SUBJECT: Forwards fire protection commitments made during May 1982 site visit, including commitment to add automatic smoke detection capability to both safety-related battery rooms. Drawing encl.

Re: St. Lucie Unit No. 2  
Docket No. 50-389  
Additional Fire Protection Commitments

Comments to Draft SSER

FLUOR DANER & LIGHT COMPANY  
 57 LUCIE PLANT  
 1915 - 890 MA(6) BIRMINGHAM  
 UNIT NO 2  
 CONTROL ROOM  
 SK NO HNO-2998-143  
 FIRE HAZARD ANALYSIS  
 FIRE DETECTORS & PROPOSED  
 CEILING OPENINGS  
 SCALE = 1/4" = 1'

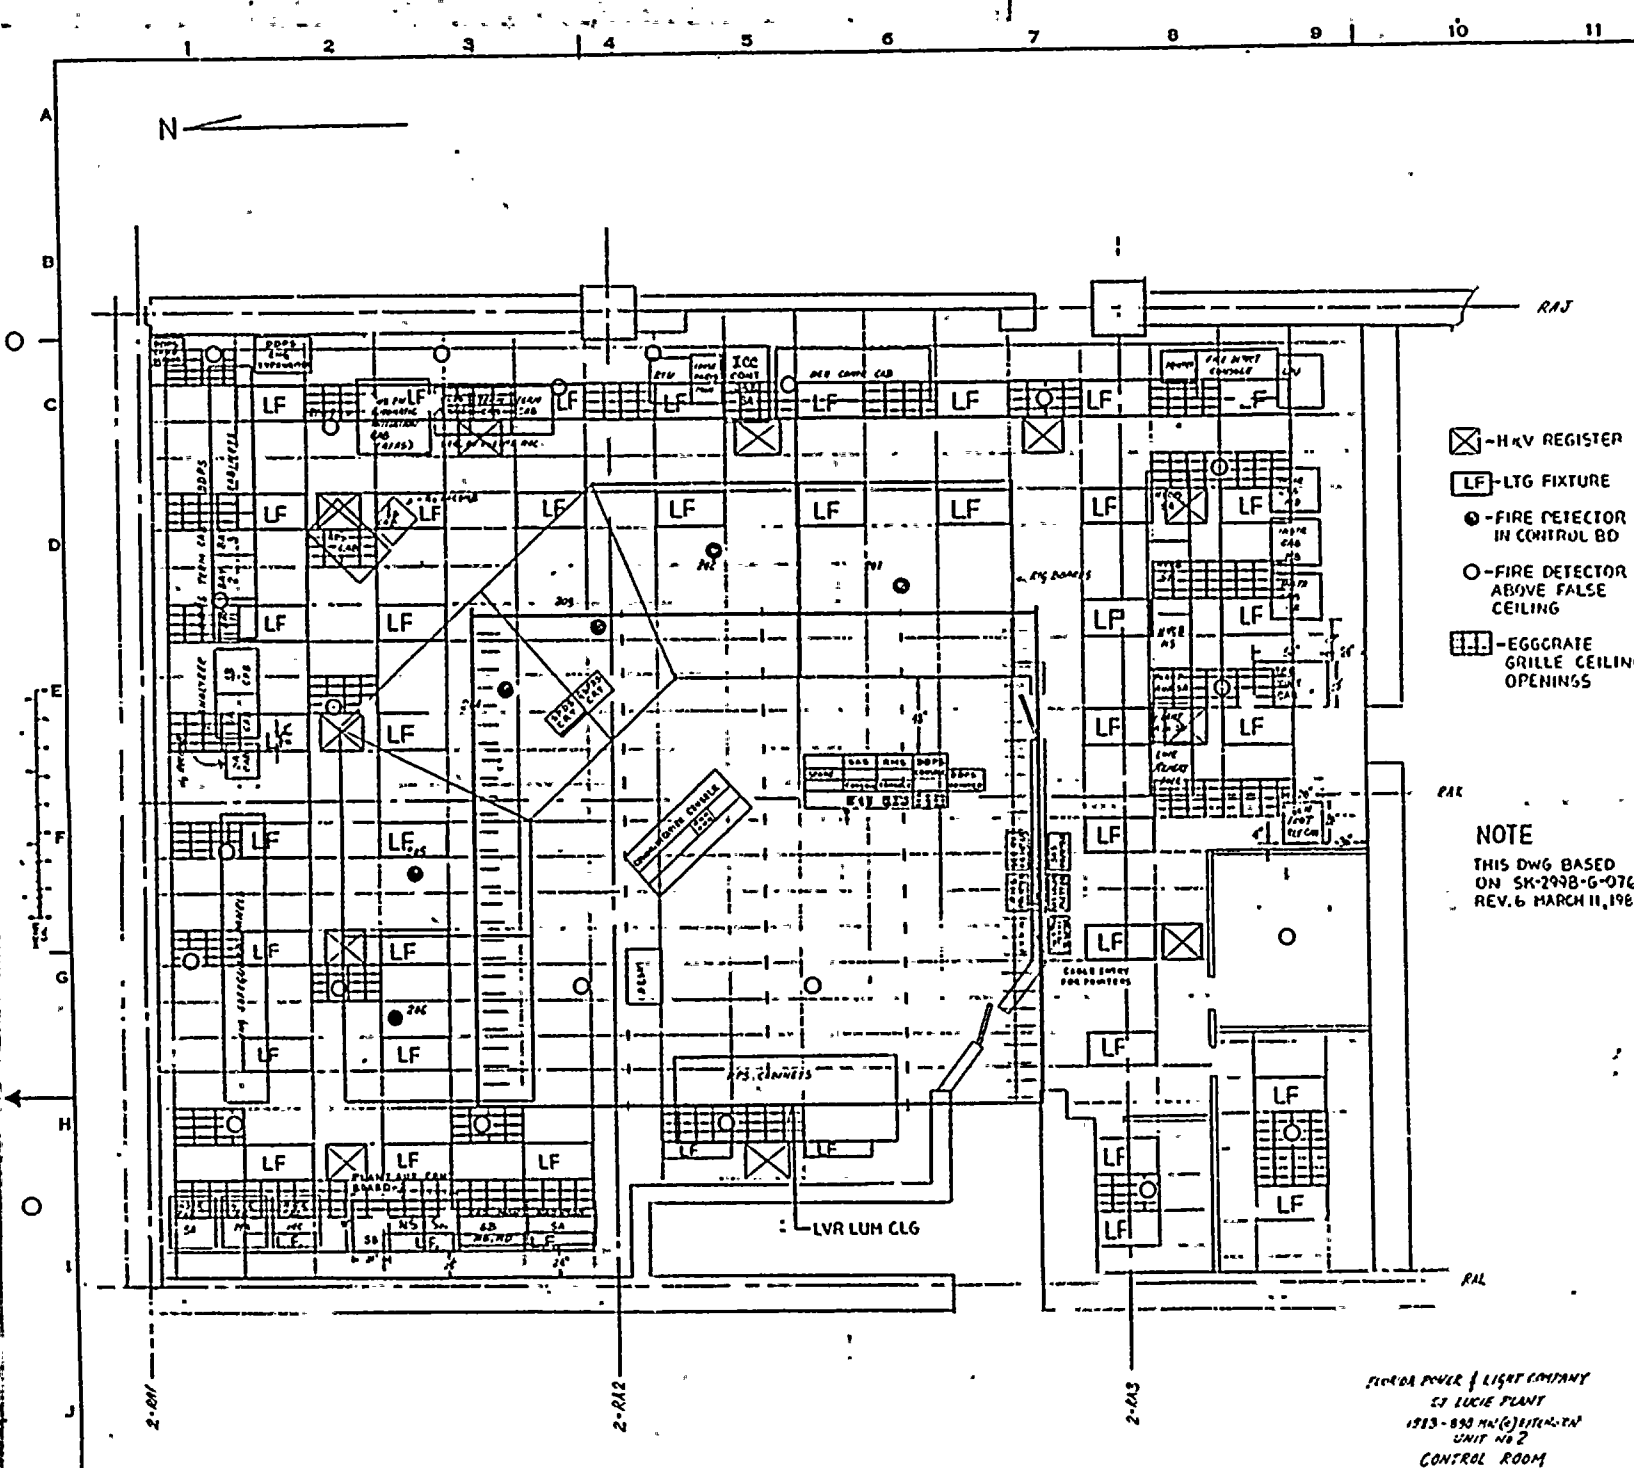
- 3) Three supplemental smoke detectors will be provided in the southeast corner of the control room. In addition, numerous solid ceiling tiles will be replaced with the open metal grid type to facilitate the flow of the products of combustion to the smoke detectors located above the suspended ceiling. These changes are reflected in sketch NYO-2998-143 (attached).
